Executive Director's Recommendation

Commission Meeting: April 5, 2018

PROJECT Building Exterior, Vestibules, and Site Improvements National Air and Space Museum Independence Avenue at 6th Street, SW Washington, DC	NCPC FILE NUMBER 7585
SUBMITTED BY Smithsonian Institution	NCPC MAP FILE NUMBER 1.41(38.00)44713
REVIEW AUTHORITY Federal Projects in the District per 40 U.S.C. § 8722(b)(1) and (d)	APPLICANT'S REQUEST Approval of preliminary and final site and building plans
	PROPOSED ACTION Approve preliminary and final site and building plans
	ACTION ITEM TYPE Staff Presentation

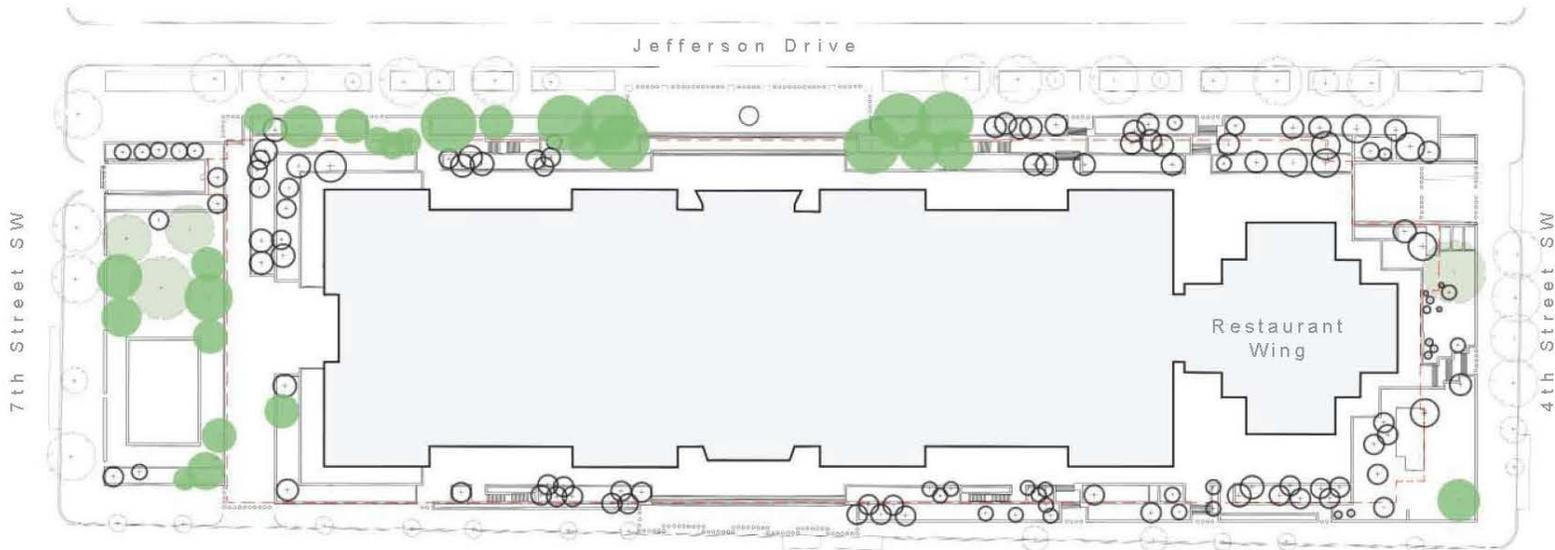
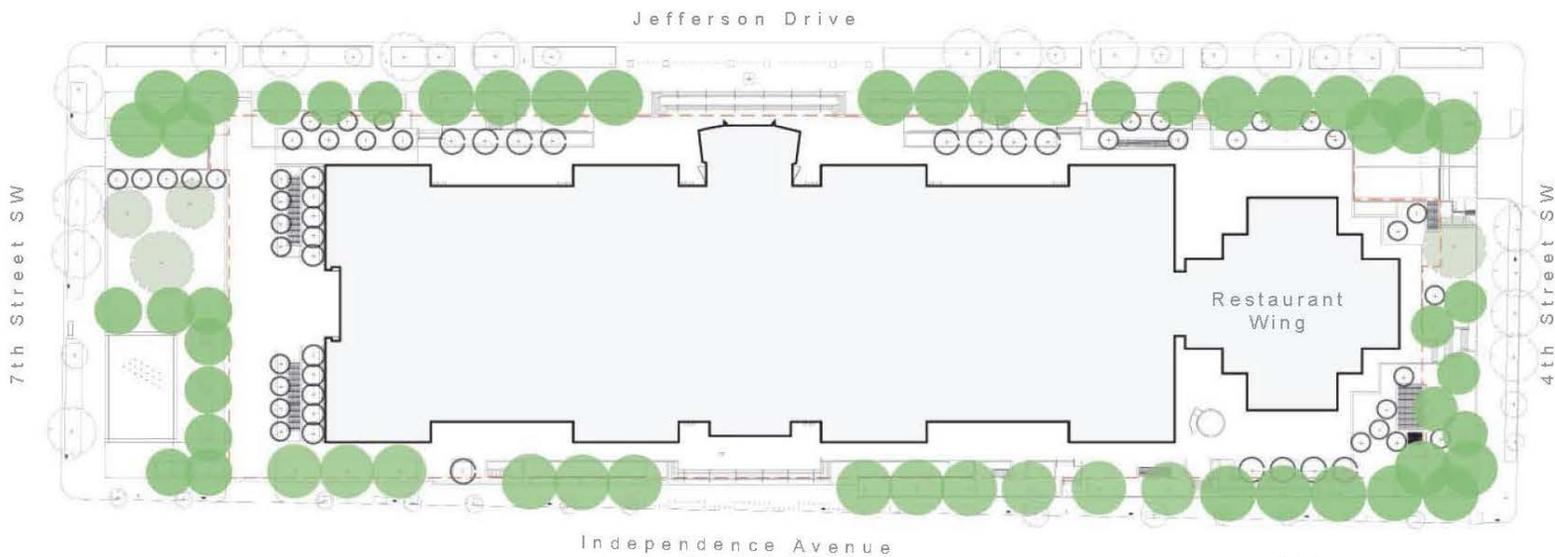
Tree Caliper: Based on tree inventory (refer to Table 1), the total existing tree caliper today is approximately 1,600 inch caliper. The total estimated proposed and preserved tree caliper in 25-30 years will be 1,659 inch caliper. Therefore, the proposed tree caliper will eventually exceed the existing conditions. The number of large shade trees in the proposed scheme (56) exceeds the number of shade trees currently on the grounds (30).

- **A landscape plan that addresses tree replacement to prevent net loss of tree canopy in accordance with the *Comprehensive Plan for the National Capital*.**
